工程指示 / 要求簡箋(E.I.)

工程指示編號：EI / 6088 / 23

工程名稱：將軍澳日出康城 11

工程項目：幕牆 單元件大貨廠用帆布遮蓋事宜

### Photo 1

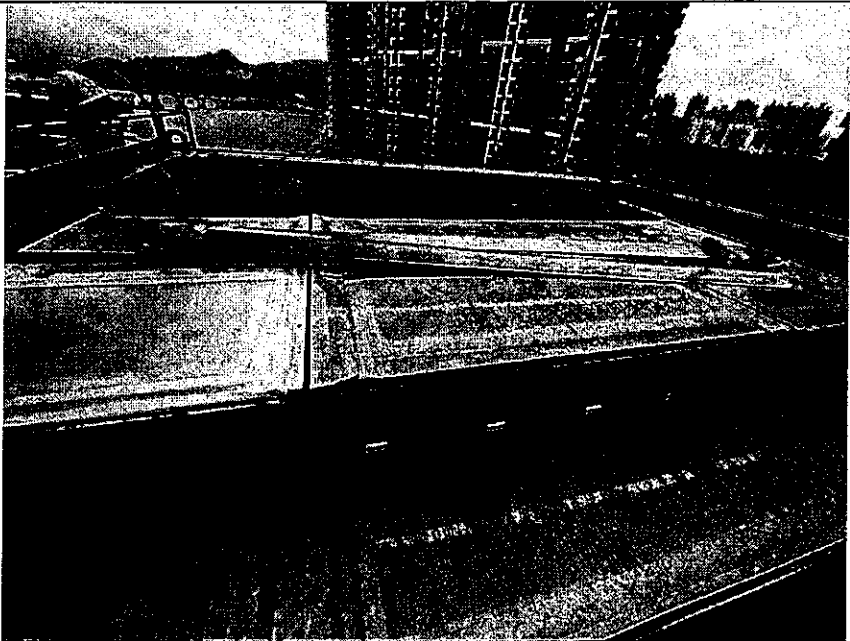
The alum. angle was observed to be placed on curtain wall glass surface. MIDI is required to separately package material by types to avoid contacting damage.

已更換保護坑紙，並提醒廠注意保護坑紙品質

**Photo 4**

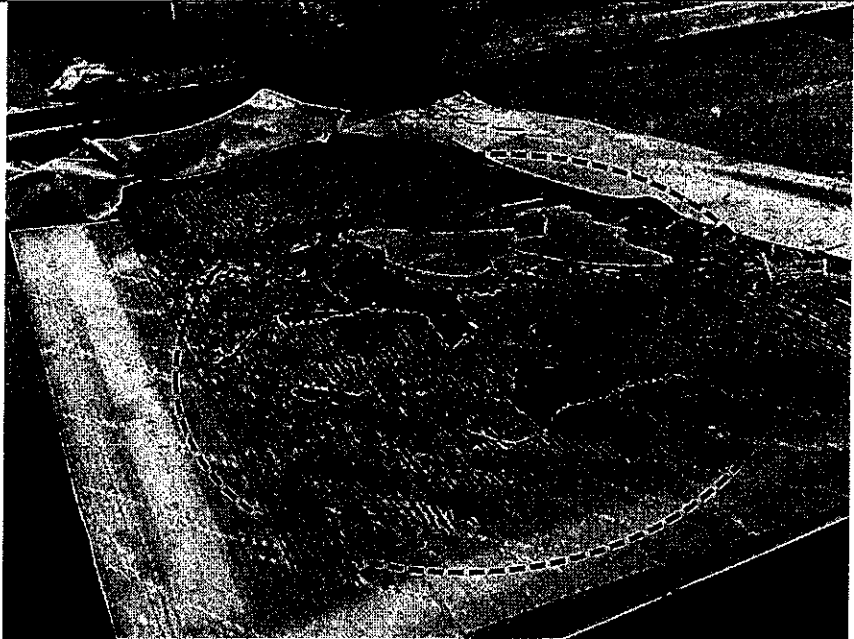
Approved method statement of protection indicates for Anti-UV Hollow Board 3mm.
